December 8, 2014
(Revised April 7, 2015)

Ref: 29011.00

Re: Silo Ridge Response to Visual Analysis Comments

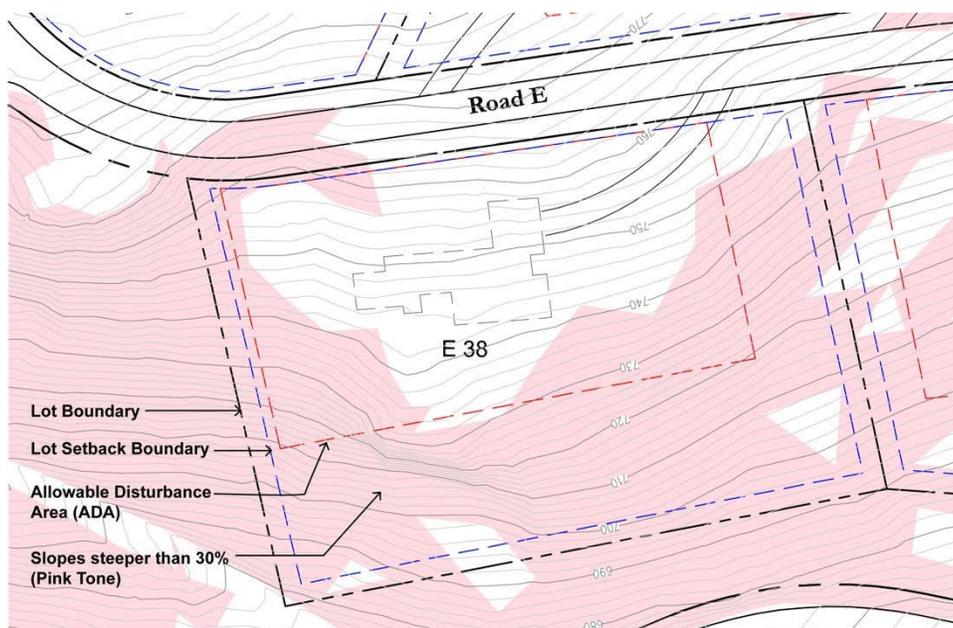
Delineation of the Allowable Disturbance Area (ADA)

The plans have been revised to show the ADA for all Estate Home lots 30,000 square feet and greater. This is the area within which all improvements (with limited exceptions) must be contained. The ADAs have been located on the shallowest existing slopes, thereby reducing the amount of grading and tree removal required for the construction of homes.

A representative estate lot indicating ADA, with ADA placement primarily in lot area with less than 30% slopes, is shown below:

All of these revisions reduce the amount of grading and tree removal in the Estate Home area, and yield a corresponding reduction of potential adverse visual impacts.
